Agenda Item # 1

SUB-003184-2024

Tate Addition Subdivision

TATE ADDITION SUBDIVISION

DETAIL SITE PLAN

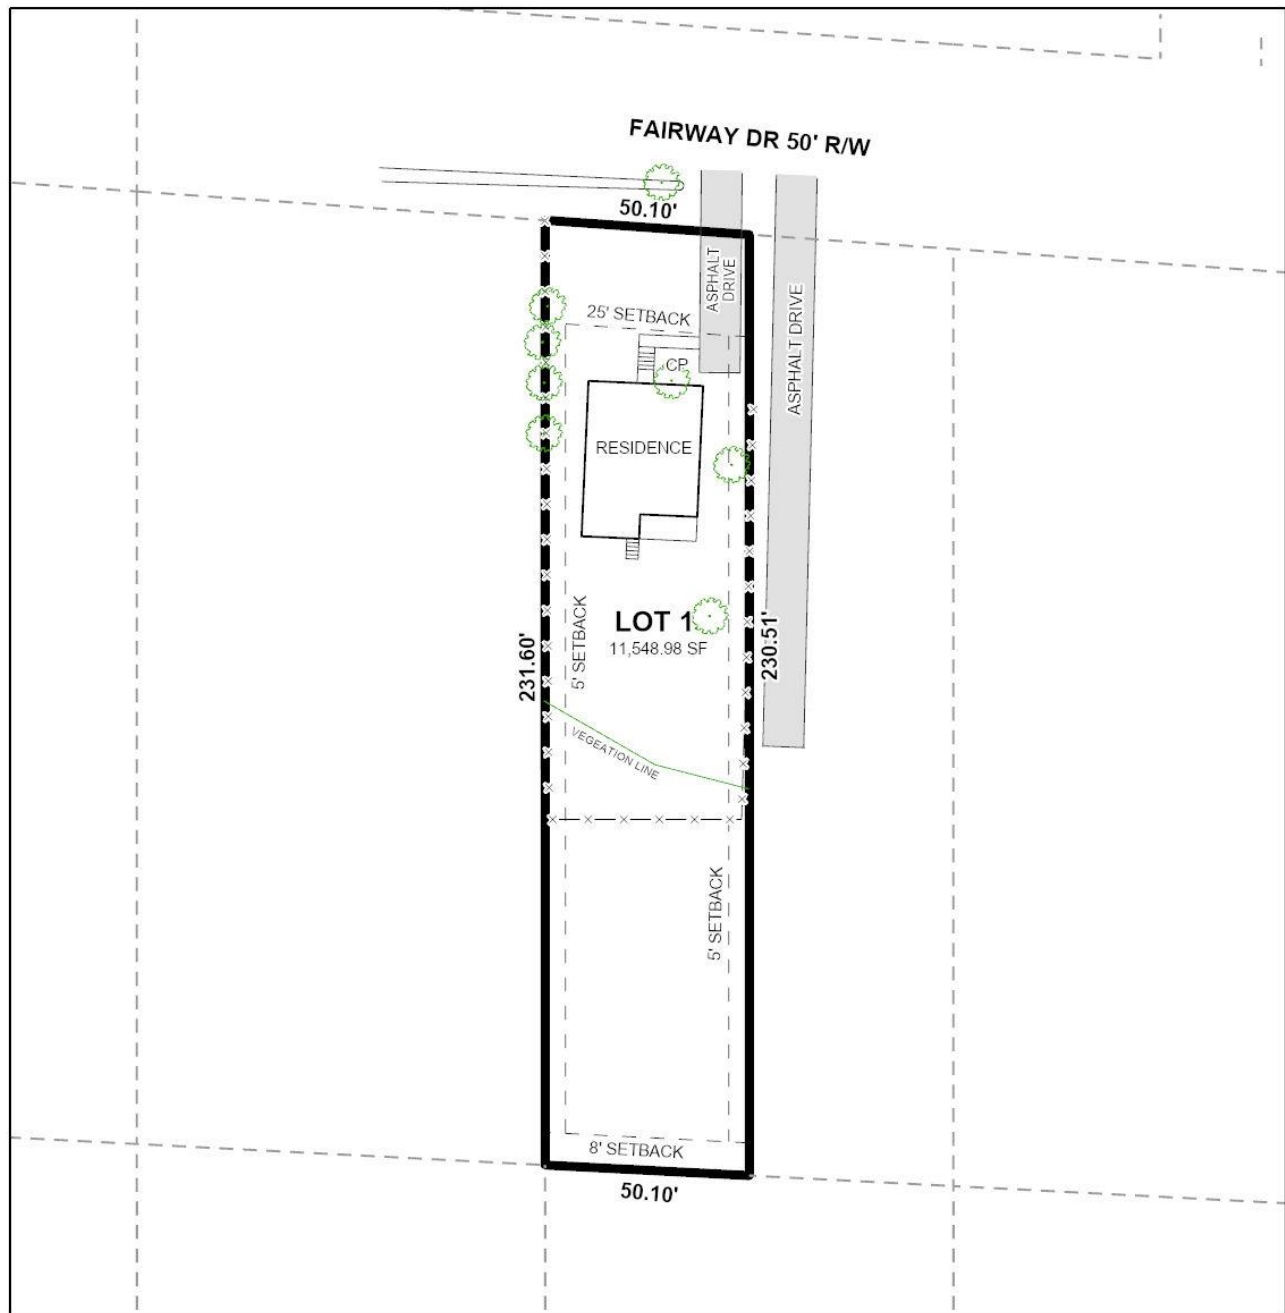
No plat was submitted as part of the request, but staff utilized the survey provided by the applicant to determine the site's compatibility with the Subdivision Regulations. A subdivision plat will be required for final approval of the request, per Section 5.A.

The site has frontage on Fairway Drive, a minor street without curb and gutter requiring a 60-foot right-of-way width. The provided survey illustrates a 50-foot right-of-way, and as such, dedication sufficient to provide 30 feet from the centerline of Fairway Drive should be required, if approved.

Section 6.C.2.(b) of the Subdivision Regulations requires all residential lots located within an area designated as suburban to have a minimum width of 60 feet, but the survey illustrates a lot width of 50 feet. It should be noted, however, that there are numerous lots in the area which also maintain a 50-foot lot width. As such, if approved, a waiver from Section 6.C.2.(b) of the Subdivision Regulations may be appropriate.

The lot, as proposed, exceeds the minimum size requirements for lots served by public water and sanitary sewer in an R-1, Single-Family Residential Suburban District. Its size, however, is only labeled in square feet and not in acres, as required by Section 5.A.2(e)(4) of the Subdivision Regulations. If approved, the size of the lot in both square feet and acres, adjusted for any required dedication, should be labeled on the Final Plat, adjusted for any required dedication; or provision of a table on the Final Plat with the same information will suffice.

The survey illustrates a 25-foot front yard setback along the lots street frontage, in compliance with Section 5.C.2.(j) of the Subdivision Regulations and should be retained on the Final Plat. However, the survey also illustrates 5-foot side and 8-foot rear yard setbacks for the proposed lot, which is not required by the Subdivision Regulations. As such, if approved, the Final Plat should be revised to retain the 25-foot front yard setback along Fairway Drive, adjusted for any required dedication, and to remove the side and rear setbacks from the Final Plat.

The survey does not provide the specifications for Final Plat approval regarding the general form, information to be shown, or attendant items required by Section 5.A. of the Subdivision Regulations. Such requirements include the items, notes, and certifications that should be placed on a subdivision plat. As such, the Final Plat should provide all

1. Provision of a subdivision plat in compliance with Section 5.A. of the Subdivision Regulations;
2. Revision of the Final Plat to illustrate Fairway Drive with compliant right-of-way and/or dedication sufficient to provide 30 feet from the centerline of Fairway Drive;

3. Provision of a label with the lot's size in both square feet and acres, or provision of a table on the Final Plat providing the same information, adjusted for dedication;

4. Revision of the Final Plat to retain the 25-foot front yard setback along Fairway Drive, adjusted for any required dedication, and to remove the side and rear setbacks;
